### DOCUMENT CHANGE REQUEST

# TRANSISTORS, SWITCHING, PNP

### **BASED ON TYPE 2N3637**

## ESCC Detail Specification No. 5208/003

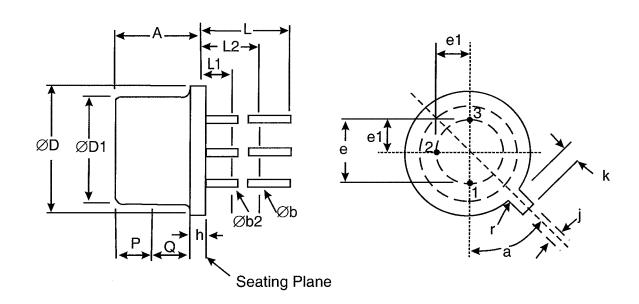
see attached

For Tamb >+25°C derate linearly to 9Wat +200°C

- 1. 2 For Variants with tin-lead plating or hot solder dip lead finish all testing performed at T<sub>amb</sub> > +125°C shall be carried out in a 100% inert atmosphere.
- 2. Superation 10 seconds maximum at a distance of not less than 1.5mm from the device body and the same lead shall not be resoldered until 3 minutes have elapsed.
